## INDEX INSTRUMENT SERVICE ADVISORY

PRODUCT:  
**IMx® (60)**

ABBOTT  
ADD**INSTRUMENT SERVICE ADVISORY****SUBJECT:**  
**IMx® Service Manual****ISA#:**  
**60-158****ORIGINATOR:**  
**Eric Tormos****PRODUCT:**  
**IMx® (60)****APPROVED:**  
**Jack B. Hall 7/7/98****EFFECTIVITY DATE:**  
**07-JUL-98**

<b>SUBJECT:</b> <b>Incorrect Orientation of Buffer Platform Switches</b>	<b>ISA#:</b> <b>60-156</b>
<b>ORIGINATOR:</b> <b>Gary Tompkins</b>	<b>PRODUCT:</b> <b>IMx® (60)</b>
<b>APPROVED:</b> <b>Bob Schabel 3/March/97</b>	<b>EFFECTIVITY DATE:</b> <b>03-MAR-97</b>

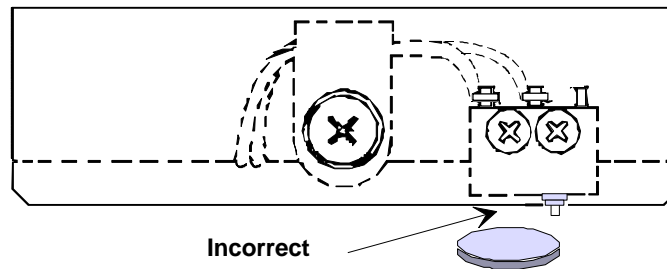
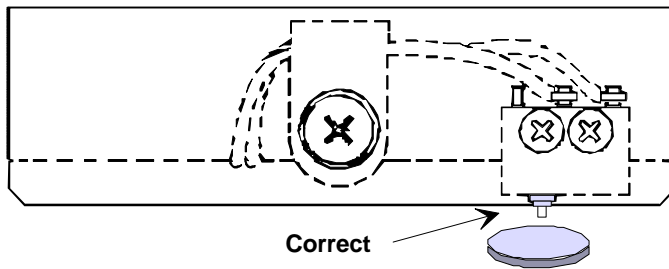
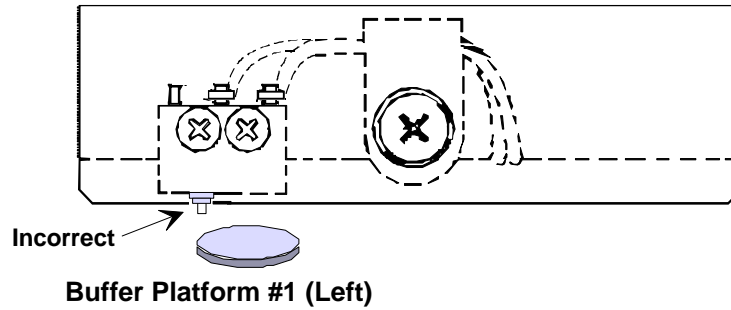
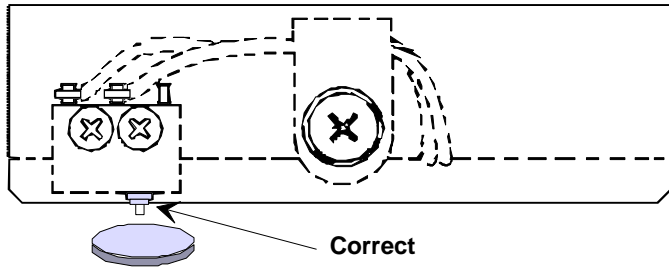
This ISA informs the Field of the incorrect orientation of buffer platform switches on IMx® Analyzers and Buffer Platform assemblies shipped in the last six months, approximately June 1996 through mid January 1997. Affected S/Ns for new analyzers begin at approximately 32300. Since refurb S/Ns are nonsequential and numerous, they are not listed in this ISA.

When servicing any IMx® Analyzer (especially those shipped in the time frame noted above), verify whether or not the buffer platform switches are installed properly. If not, remove and reinstall them in the correct position as shown in the diagram below. It will be necessary to remove the platforms to access the switches as they are secured by small screws and nuts. Once rework is complete, perform the Buffer Sensor Check, VP-15 in the IMx Service Manual.

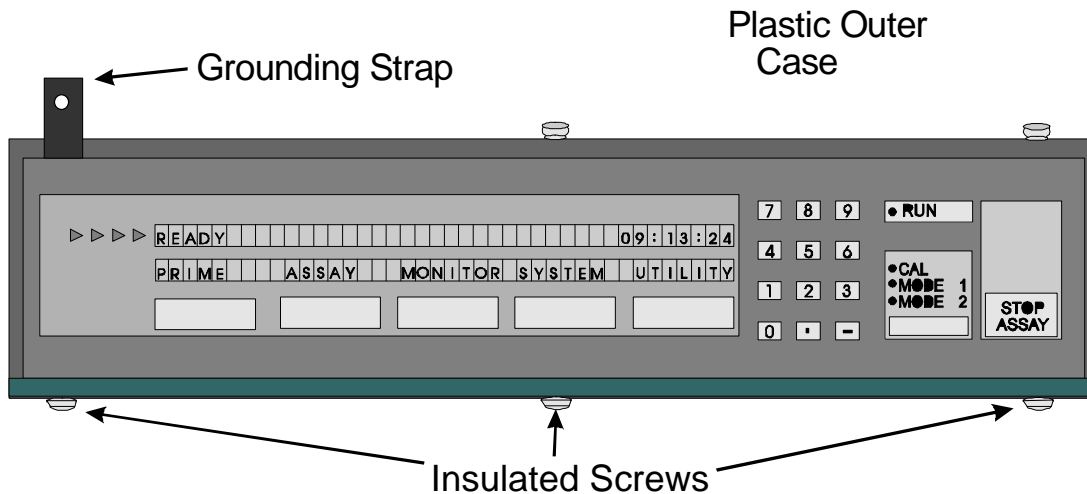
This ISA explains the new style of keypad used in the top half of the touchpad assembly (3-04531-02). The new keypad and attaching hardware reduces the instruments susceptibility to static discharge. The keypad is now available as a separate part with the mounting hardware (3-47312-02). The main differences in the keypad are that it is now plastic and has a grounding strap to be attached under the upper left screw, and three insulated screws (see illustration on page 3 of this ISA for location). This change was introduced to resolve potential issues related with FACTORY SET and/or CHECKSUM ERROR due to electro-static discharge.

Once you use up your 3-04531-01 Touchpad in your parts kits, it will be replaced automatically with the 3-47312-02 Keypad. The 3-04531-02 Touchpad will not be stocked in your parts kits. The 3-04531-01 Touchpad will no longer be available.

Whenever you suspect that a FAC\_SET or CHECKSUM error has occurred because of static discharge, insure that you install the 3-47312-02 Keypad or the 3-04531-02 Touchpad. It is more cost effective to replace the Keypad rather than the entire Touchpad assembly. When installing the keypad onto the base of the touchpad (piece where the display is mounted to), insure that the ground strap is fastened under the upper left hand screw of the touchpad. Use the three (3) insulated screws on the bottom of the Keypad since these will be exposed to external electro static sources. more than the top of the Keypad. See illustration on page 4 of this ISA.

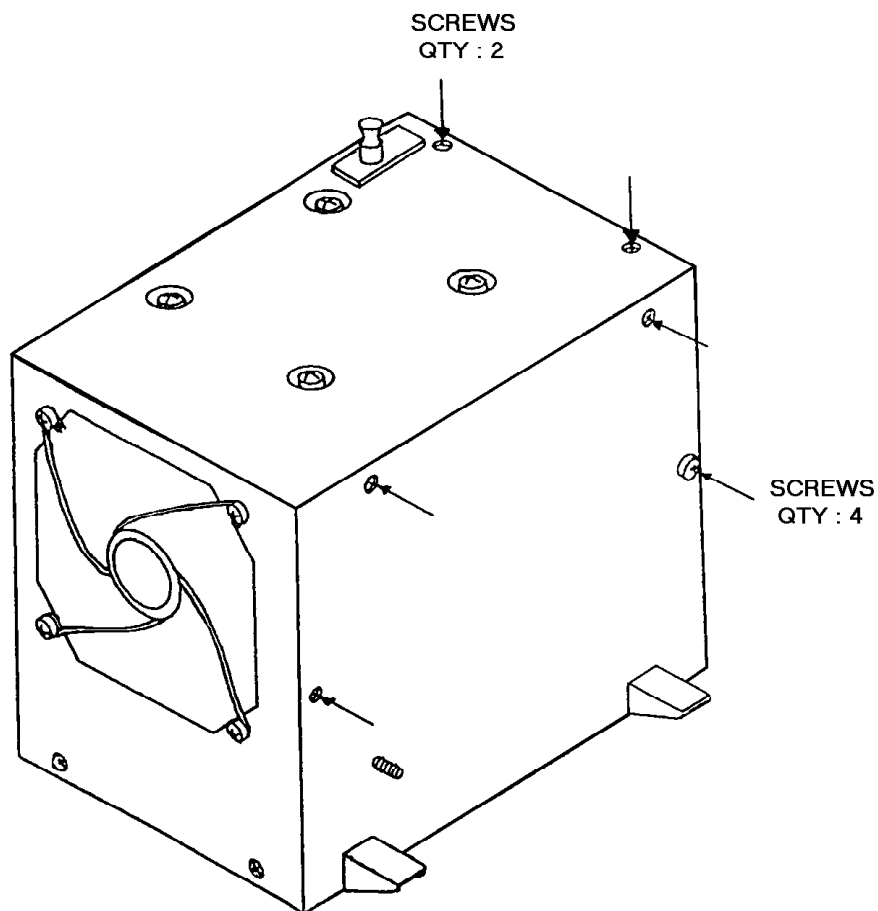
Remove and save the four screws from the opposite side of the supply (see Figure 2).

Remove and save the two top screws next to the interlock switch (see Figure 2).

### Assay Files

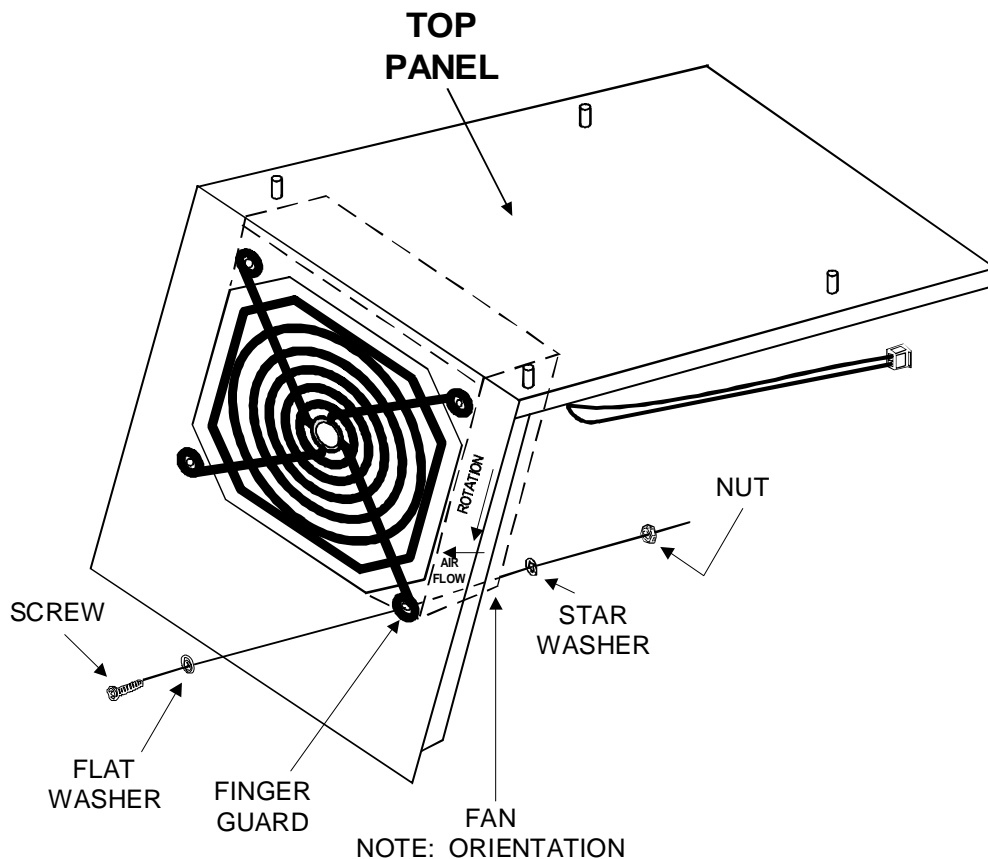
Orient the new fan such that the airflow moves from the inside of the supply to the outside (see Figure 3). The fan cable should be located in the top right corner of the fan.

Reinstall the finger guard and new fan per Figure 3 using the existing screws, flat washers, star washers, and nuts.
